Certificate of Appropriateness
BAR # HST25-0112
159 Madison Lane, TMP 090145000
The Corner ADC District (contributing structure)
Owner: Montalto Corporation
Applicant: Paul Tassell / The Gaines Group
Project: Misc. repairs/improvements to south porch

**City of Charlottesville
Board of Architectural Review
Staff Report
November 18, 2025**

BAR # HST25-0112

Project: Masonry repairs and rehabilitation work at south elevation

FRONT PORTICO BASEMENT WINDOWS -

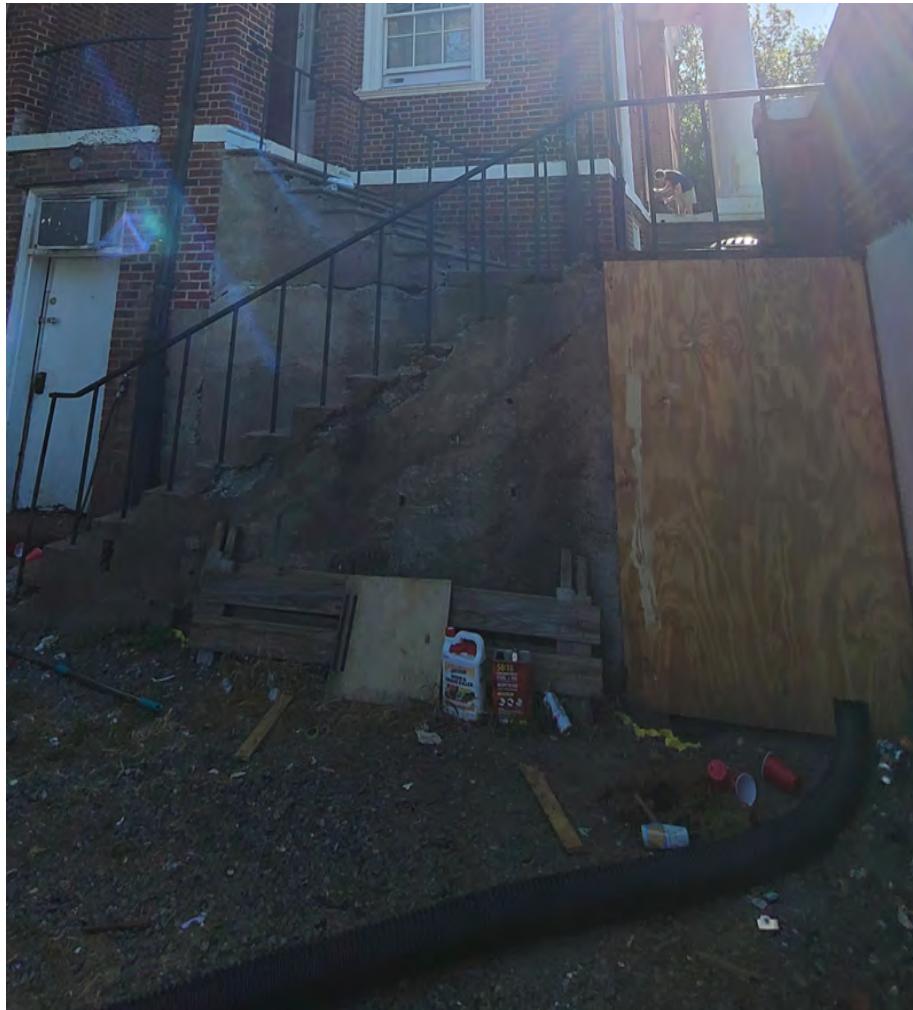
Portico basement windows have been boarded up due to vandalism. We are proposing infilling these window openings with brick that matches the existing, recessed 1/4".

Exterior stair nosings have seen various repairs to solve deterioration and to re-secure railings to stairs. Exterior stairs will return to their original design of 1 1/2" bull-nosed concrete treads and a 1" overhang.

- Existing railings will be reused; however, if existing are not salvageable, the new will reasonably replicate the existing, with the understanding that dimensions might be modified to meet code requirements.
- Approval of the infill, with brick, of the three, basement-level windows at the front of the porch must follow these parameters: the coursing, brick color and mortar be matched as closely to the historic as possible, and that the infill with brick be set 1 inch back from the plane of the brick wall.
